RAI PA-1

RAI AQ-4

Table 4.6-1
NAAQS Compliance Demonstration – Phase 1
(5 pages)

Figure AQ-5-1
Emission Estimates by Pollutant for Each Phase of Construction for the CISF

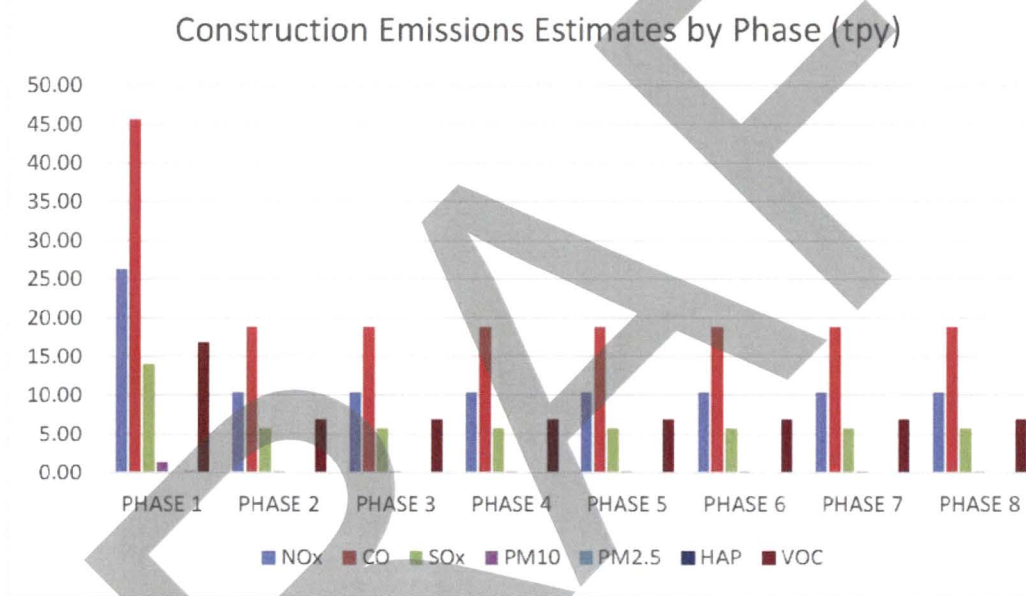
- Complete range of emission sources and activities associated with the proposed action (see RAI AQ-4).
- Provide estimated emission levels (e.g., tons per year) for the activities and sources associated with the proposed CISF accounting for the various topics raised in the previous bullet points specified in this RAI (i.e., individual stages, overlapping of stages and phases, pollutants other than particulate matter PM10, range of emission levels) or provide a basis for not providing any aspects of this information.

ER Section 1.3.2.3 identifies that both the construction and the operation activities generate air emissions. ER Section 4.5.3 states that the CISF could be built in eight phases and indicates that this phased approach means that construction and operation activities could overlap at times. ER Section 4.5.3 also indicates that the first phase would also include site infrastructure construction (e.g., facilities, the railroad side track, possibly a new concrete batch plant). The air impact analysis in ER Section 4.6 (i) does not clearly identify the proposed action's highest annual or peak year emissions considering the possible overlap of stages (i.e., construction, operation, and decommissioning) or phases as well as the distinction in construction emission levels between Phase 1 and the subsequent phases, (ii) only considers particulate matter, (iii) does not consider combustion emissions from mobile sources, and (iv) only provides estimated annual emission levels for the concrete batch plant (note that these emission level estimates in ER Table 4.6.2 do not specify units). The EIS analyses need to consider the peak year emission levels since this relates to the largest potential impacts from the proposed action.

Emission estimates have been developed for construction and operations activities at the CISF and may be found in Tables 1-9 of Excel™ Spreadsheet T190815_EMISSIONS ESTIMATES.xlsx included as an Enclosure referenced in RAI Response AQ-4. Emissions are broken down by equipment/activity type and are based on the construction phase and operations year.

The majority of emissions associated with the CISF are estimated to take place during the initial construction phase (Phase 1) and will constitute the project's "peak year" emissions (Table 7 of Excel™ Spreadsheet T190815_EMISSIONS ESTIMATES.xlsx). Phase 1 construction is expected to begin in 2021. Each subsequent construction phase is expected to have the same level of emissions and will take place approximately every 2 to 3 years starting in 2024. Operations emissions are expected to remain the same from year to year (Table 8 of Excel™ Spreadsheet T190815_EMISSIONS ESTIMATES.xlsx) and will overlap construction Phases 2-8 (Table 9 of Excel™ Spreadsheet T190815_EMISSIONS ESTIMATES.xlsx). Figure AQ-5-1 illustrates emission estimates by pollutant for each phase of construction with the exception of CO₂, which is included in Table 7 of Excel™ Spreadsheet T190815_EMISSIONS ESTIMATES.xlsx.

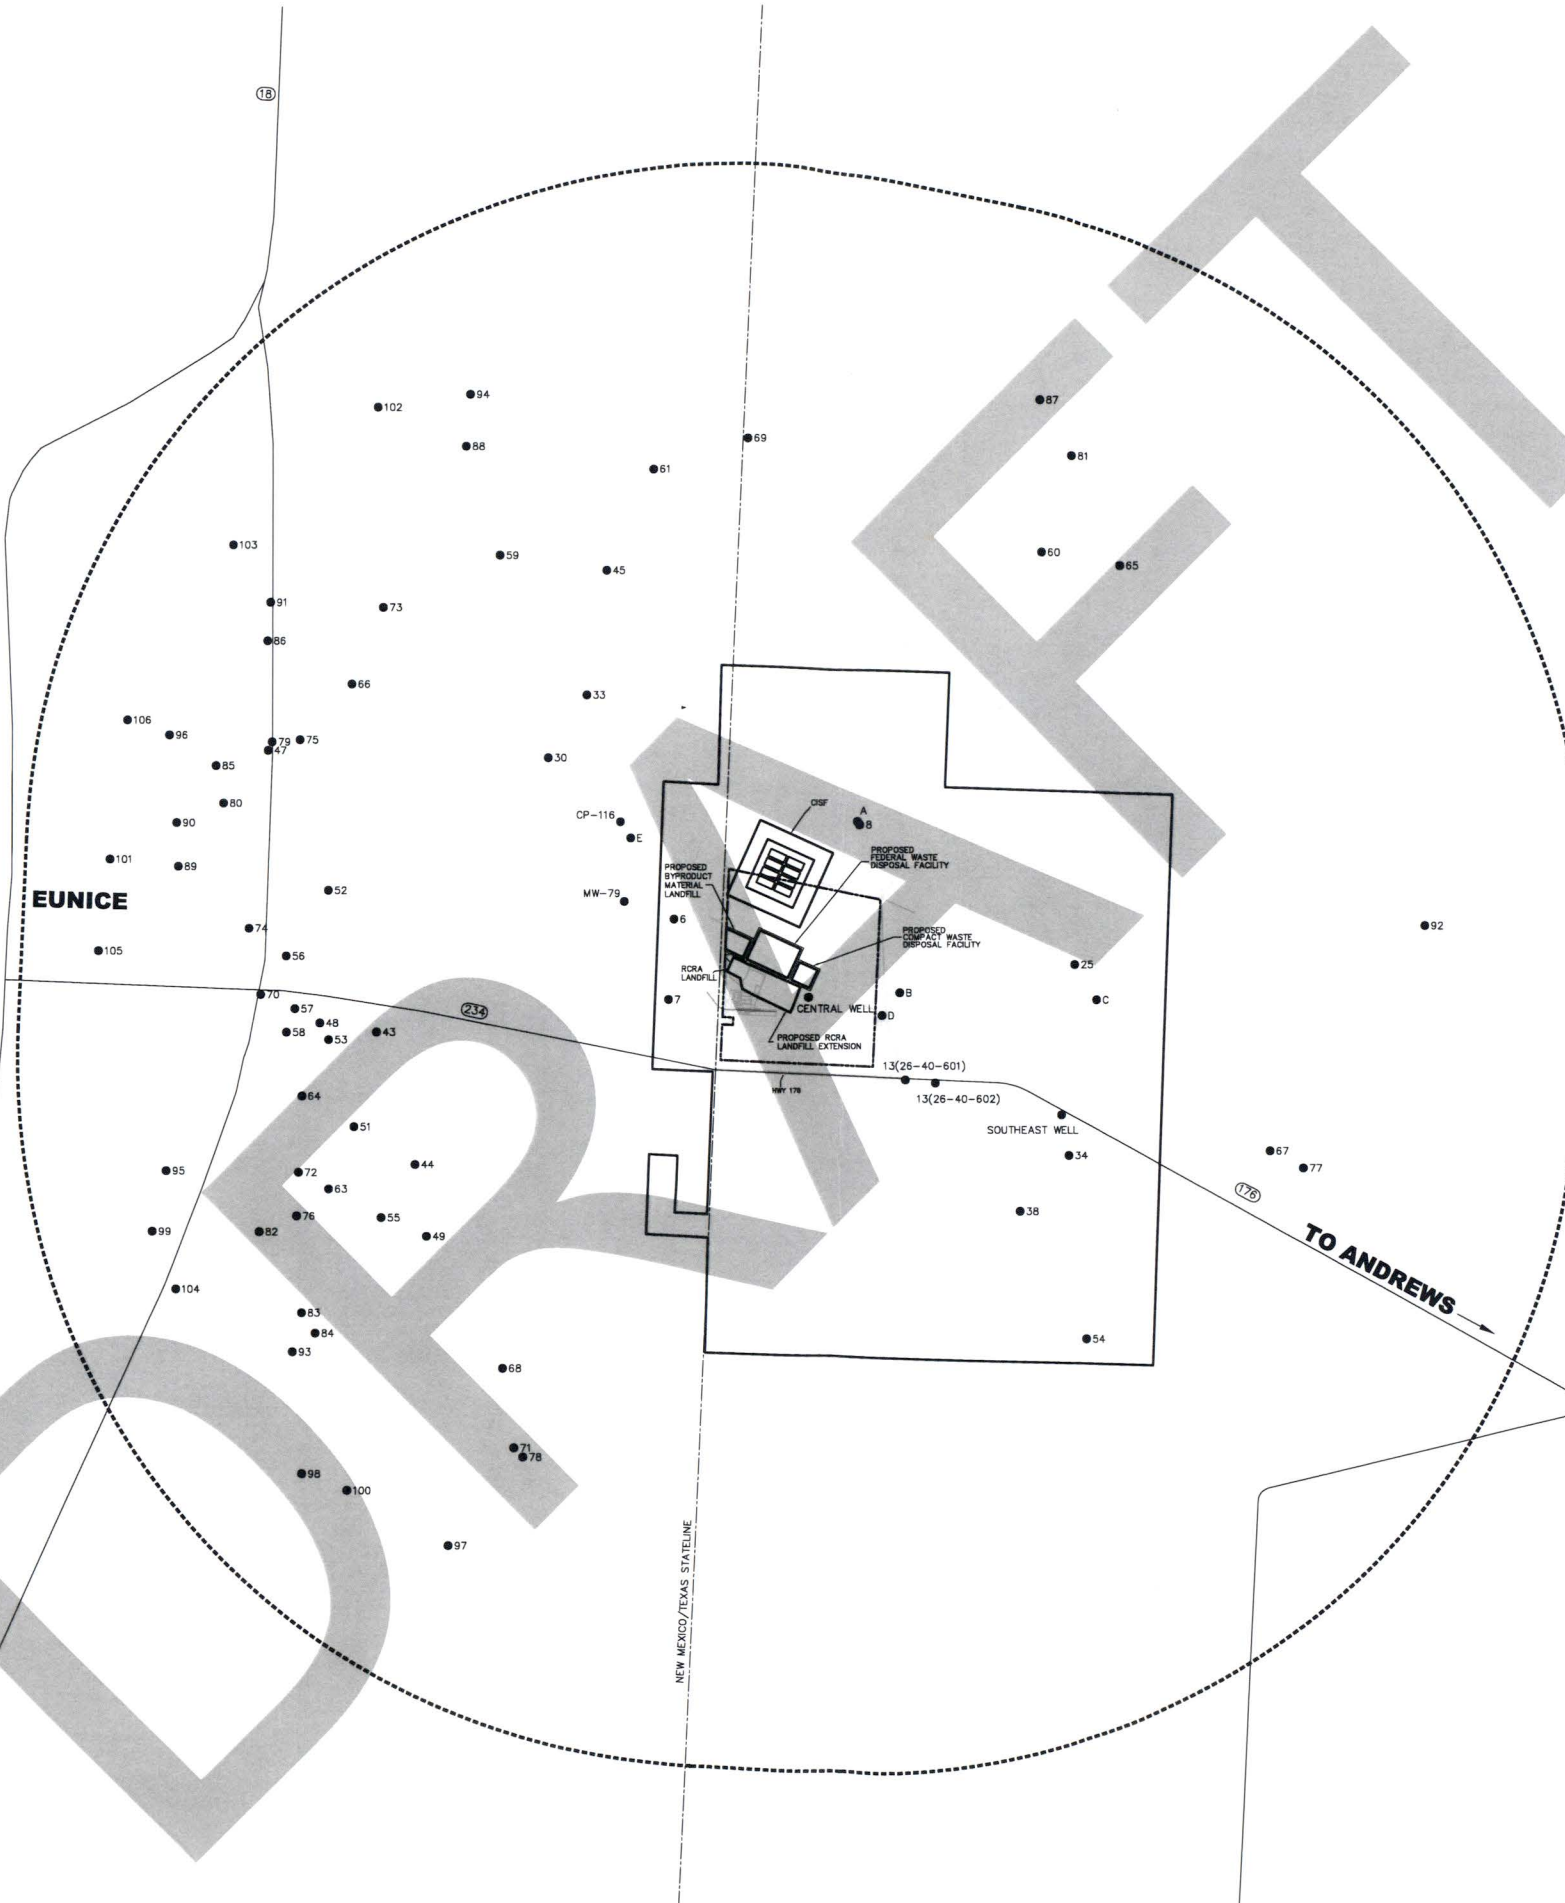
Provide additional information on the proposed pre-operational and operational Radiological Monitoring Program for the proposed CISF. The additional information should include:

- Media or effluents to be sampled are air, soil and ambient radiation as stated in Section 9.6.2.4 of the WCS CISF SAR.
- Number and location of sample collection points, including distal control sample collection points are as indicated on ER Figure 6.1-1. An additional four optically stimulated luminescence (OSL) locations and two soil sample locations are being proposed for the CISF to supplement the existing Waste Control Specialists REMP sampling locations indicated in ER Figures 4.12-7 through 4.12-12. Three existing OSL locations are shown in ER Figure 6.1-1; there are two existing soil sample locations and three existing air sample locations that are co-located with these existing OSL locations. These three existing air locations will be the air monitoring locations for the CISF in addition to the operational air monitoring within the Cask Transfer Building. With the two existing soil sample locations and three existing OSL locations, there will be a total of six soil sample locations and seven OSL locations proximal to the CISF (not counting the other Waste Control Specialists REMP sampling locations more distant). The distal control sample location (air, soil and ambient/OSL) is three miles east of the Waste Control Specialists Facility on the south side of State Highway 176 as indicated in the bottom right corner of ER Figures 4.12-7, 4.12-9, and 4.12-10. ER Figure 6.1-1 has been updated to reflect the updated path of the rail spur to the proposed CISF. ER Figures 4.12-7 through 4.12-12 show the locations of the various types of environmental samples that are collected at Waste Control Specialists. One of the background locations (Station 9) is located in the bottom right corner of Figures 4.12-7, 4.12-9 4.12-10 and 4.12-12.

ER Sections 6.3 and 9.0 and Figure 6.1-1 have been revised as described in the response.
